N1094A-01

Modification Recommended Service Note

N1094A DCA-M Sampling Oscilloscope (Dual Electrical Channel)

Replace the left front panel overlay that shows the new clock input level at 1.4 Vp-p Max.

Figure 1 Updated overlay - should say 1.4 Vpp Max

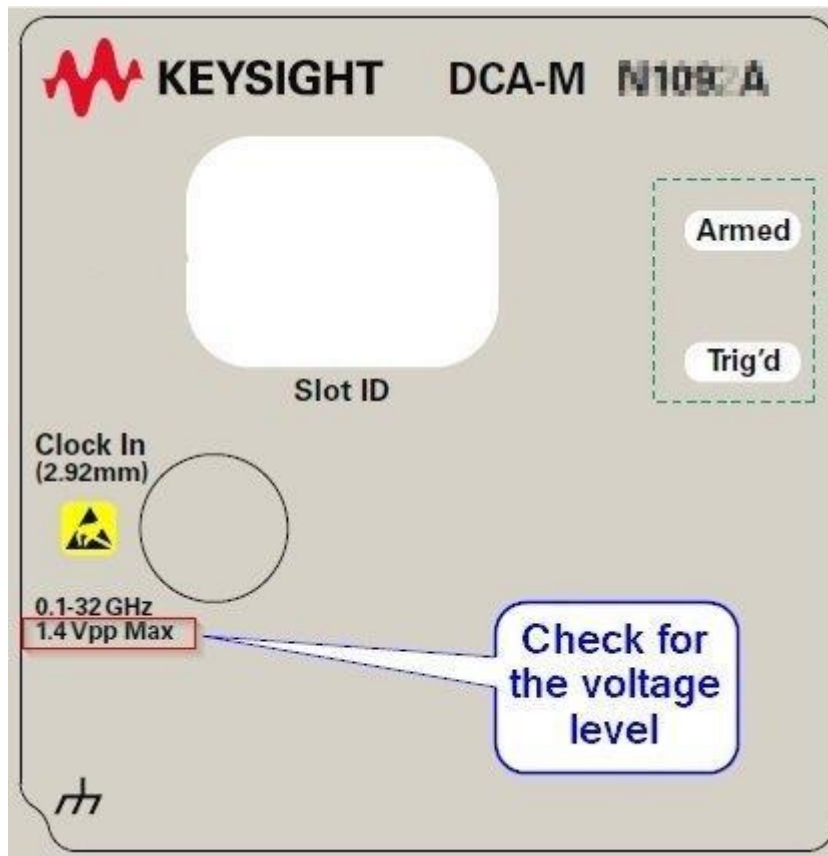
In May 2018, the clock's input port maximum signal voltage changed from 2.0 Vp-p (old value) to 1.4 Vp-p (new value). This is very sensitive circuitry and this change provides additional margin to reduce risk of damage to the instrument.

New instruments shipping after this change has the new left front panel overlay with this updated information, see Figure 1 below.

If the front left panel overlay shows 2 Vp-p (old value), remove the old overlay and replace it with the new overlay that shows 1.4 Vp-p (new value). If the customer has added any asset tags, or other customer information to the old left front panel overlay, it is recommended to send back the old overlay to the customer after it has been removed.
